STATE OF NORTH CAROLINA  
DEPARTMENT OF TRANSPORTATION

Subject: **Response to US Army Corps of Engineers Letter** for the proposed NC 133 Connector from NC 211-133 (Southport Supply Road) to NC 87-133 (River Road), Brunswick County, TIP R-3324.

References: Application for an Individual Section 401 Water Quality Certification dated July 19, 2012  
USACE Request for Additional Information Letter dated, September 18, 2012 (received September 24, 2012).  
NCDOT Response to US Army Corps of Engineers Letter dated, October 18, 2012.

# SITE XII

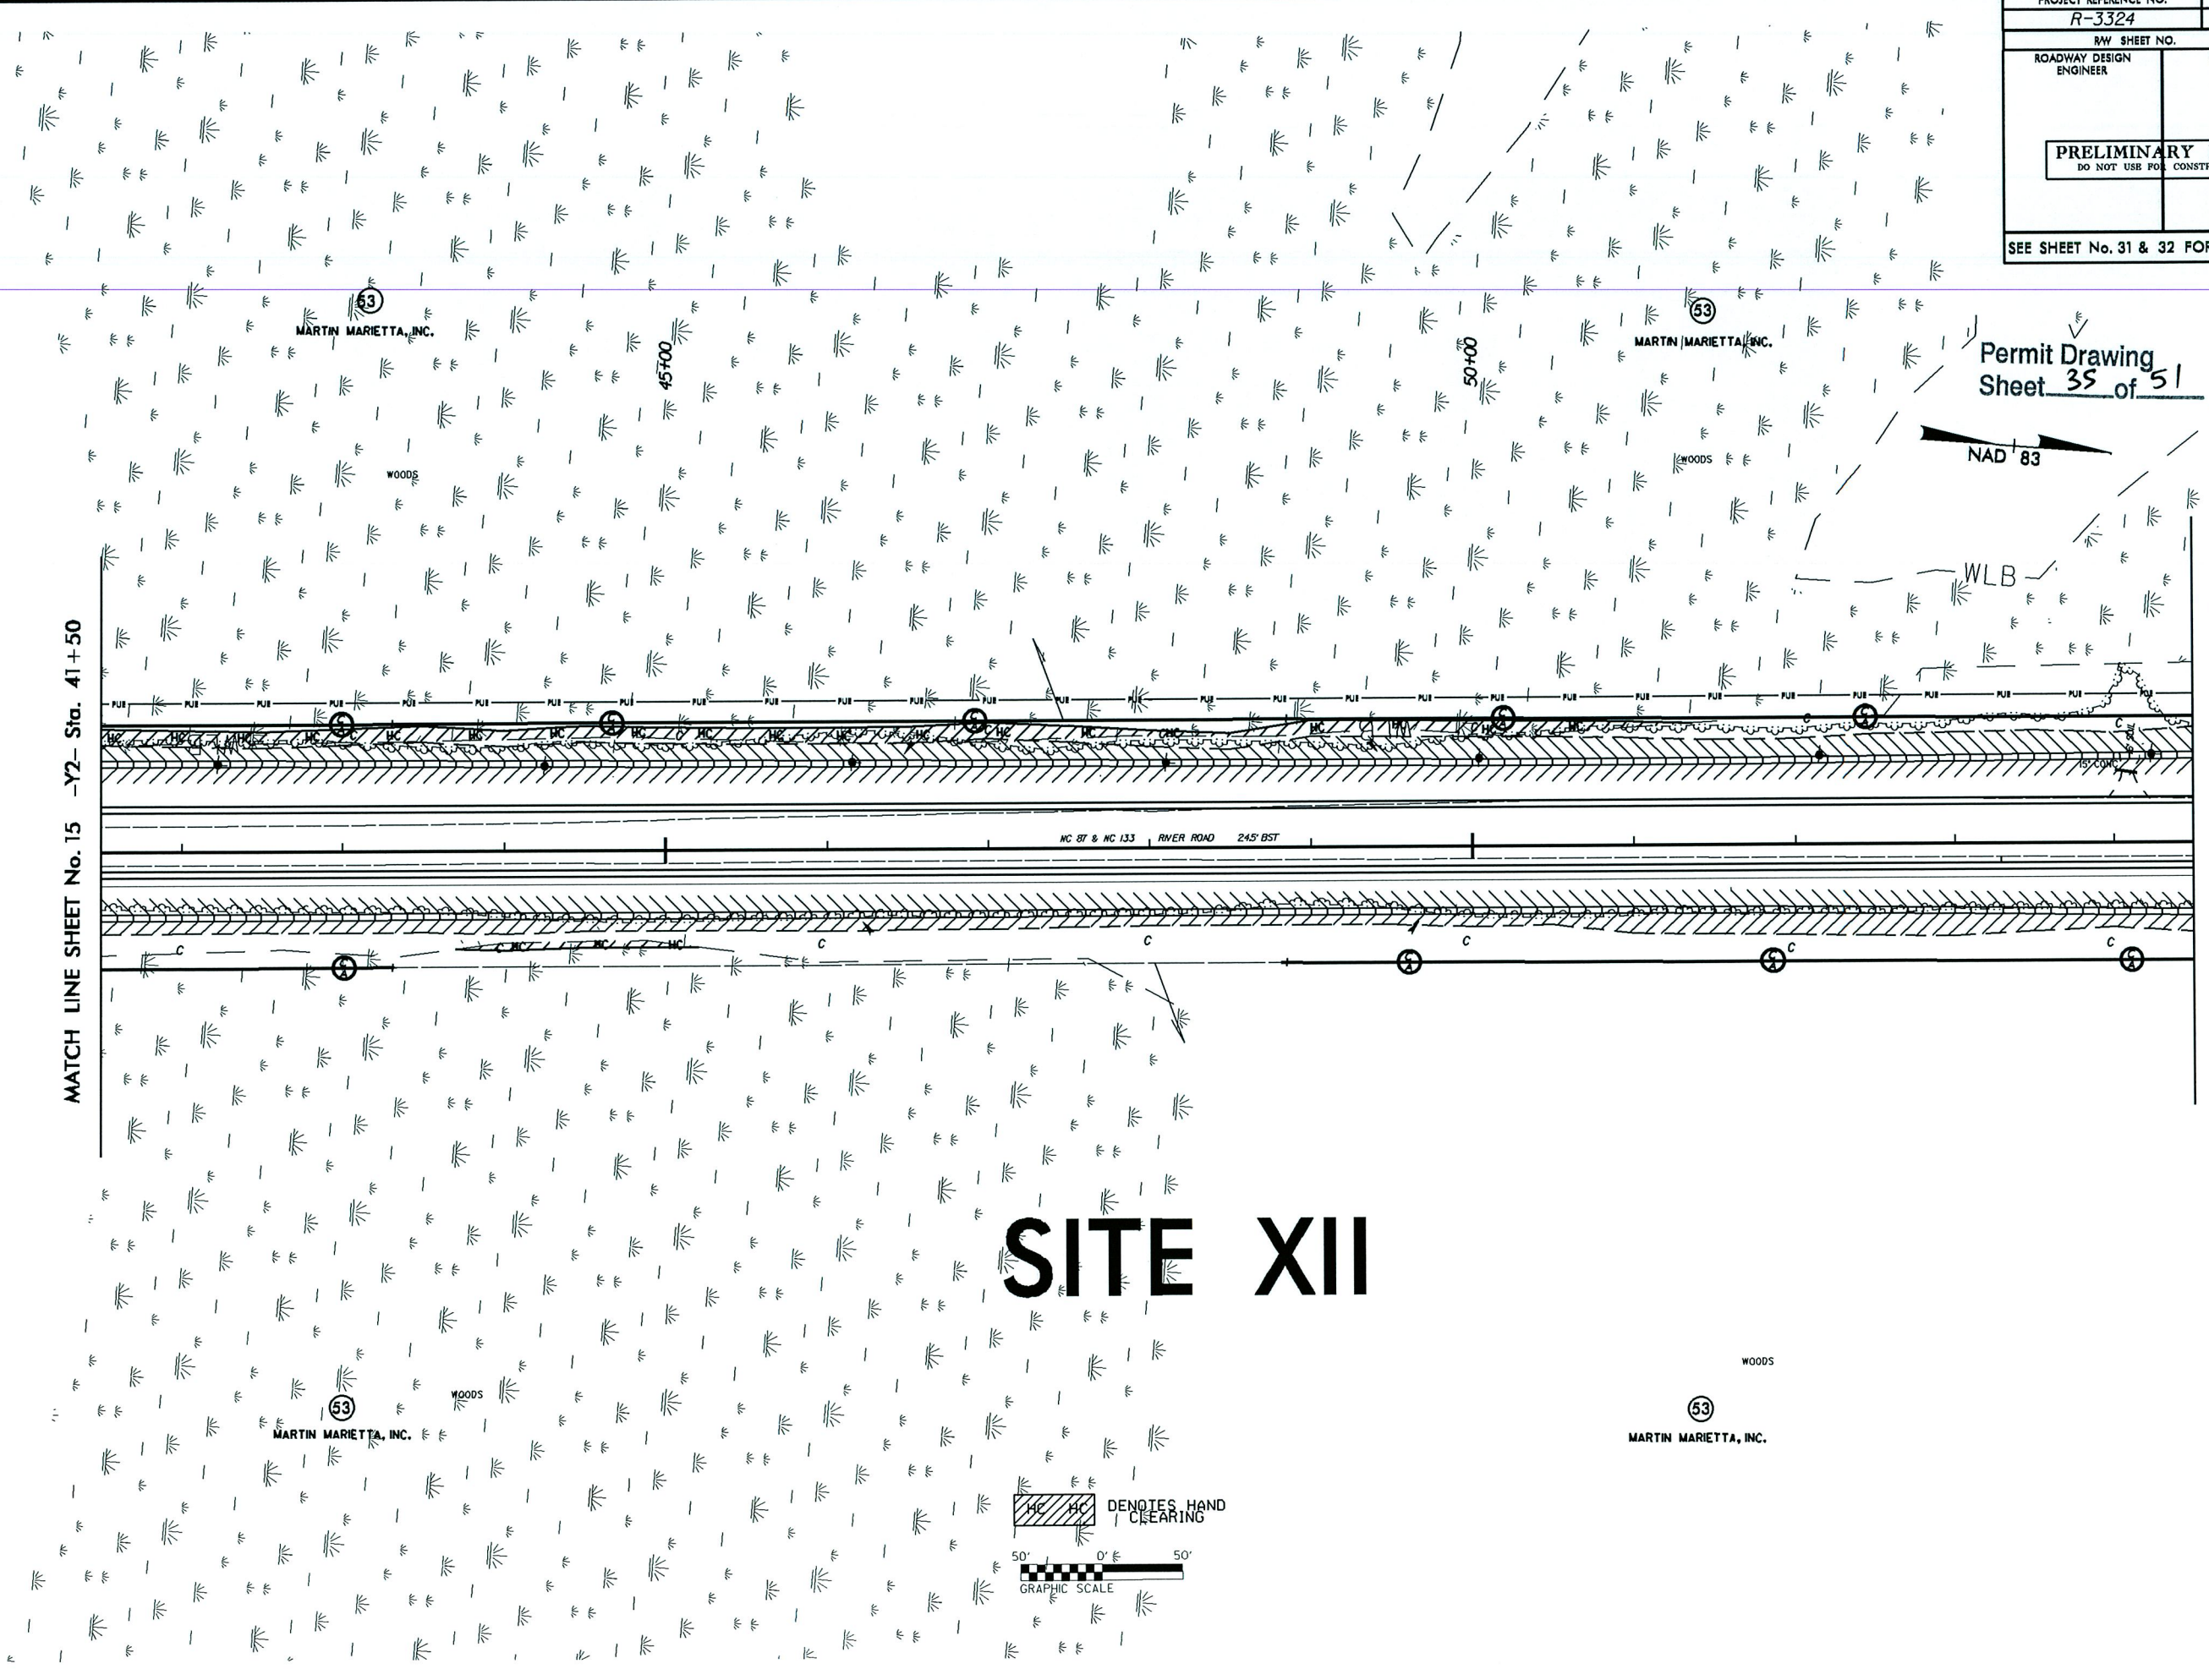
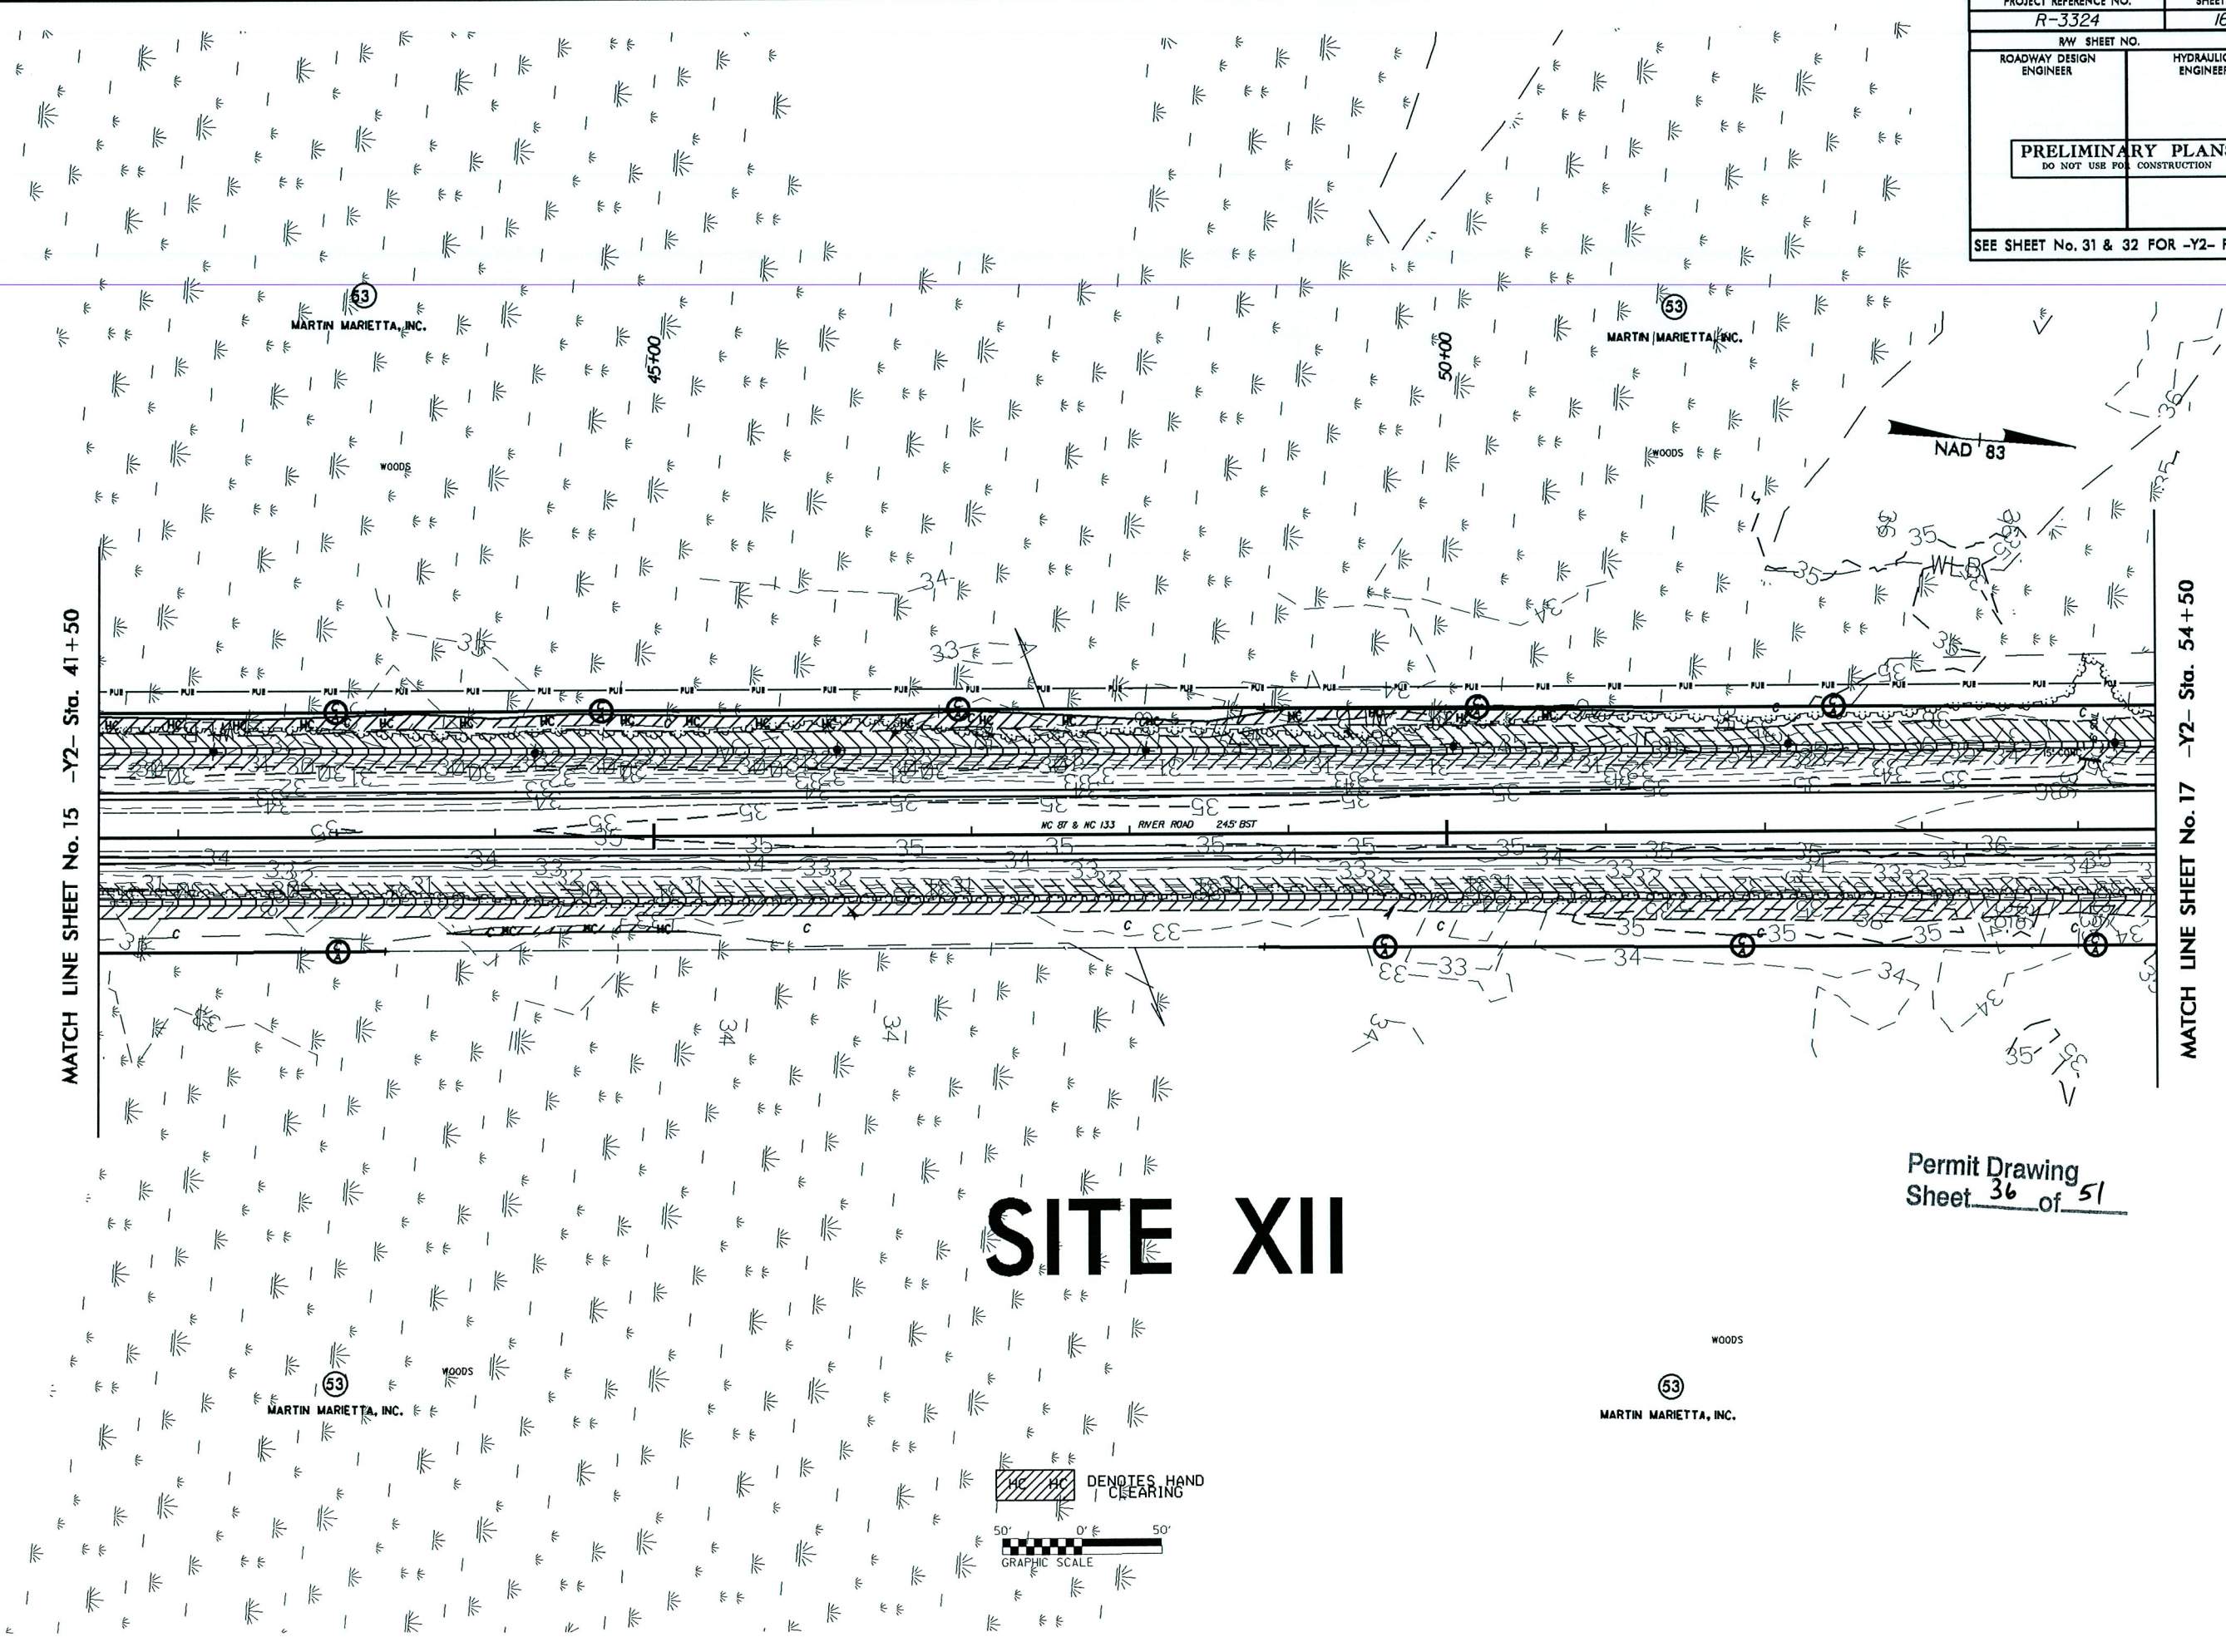
10. Site 12: *Any utility easement with forested wetlands being cleared and maintained should have mitigation proposed for associated impacts.*

11. Site 12: *Existing ditches along NC 87/133 are being moved further into and along wetland areas. The USACE would suggest using the Skaggs method to determine the lateral influence of moving the ditches and then would propose an appropriate mitigation plan.*

Response provided in previous correspondence.

Response provided in previous correspondence.

PROFILE  
SITE IV

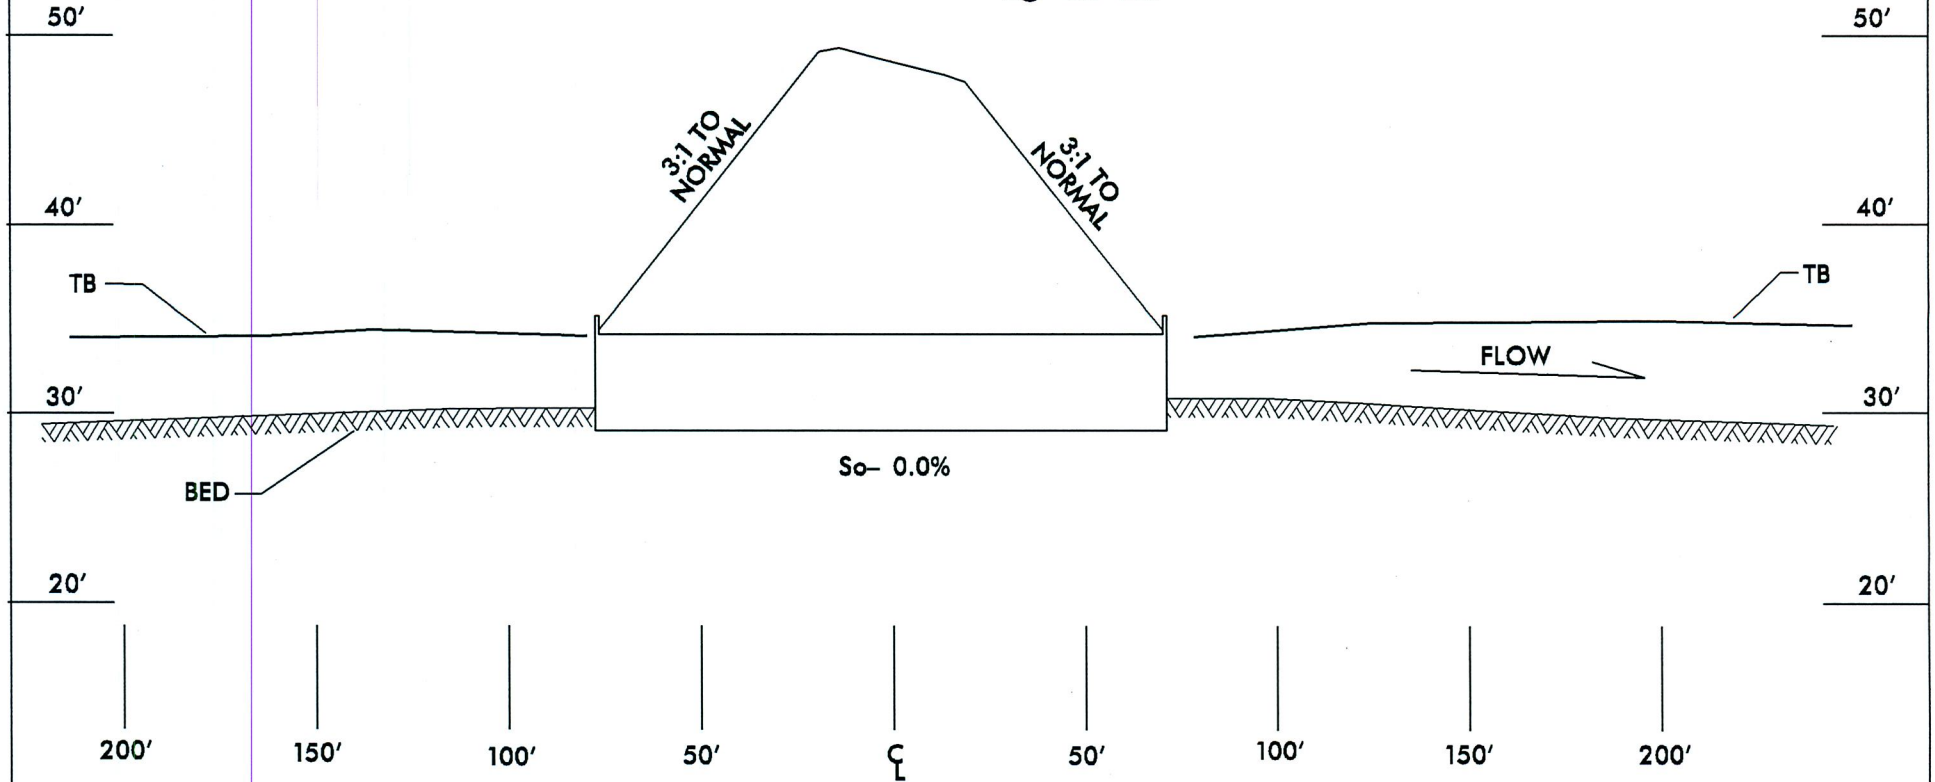
*- Will twin 60" culverts need dewatering and temporary stream impacts outside permanent impacted areas?*

There is no need for temporary stream impact as the channel change and pipes can be installed in the dry and then have the water turned through them.
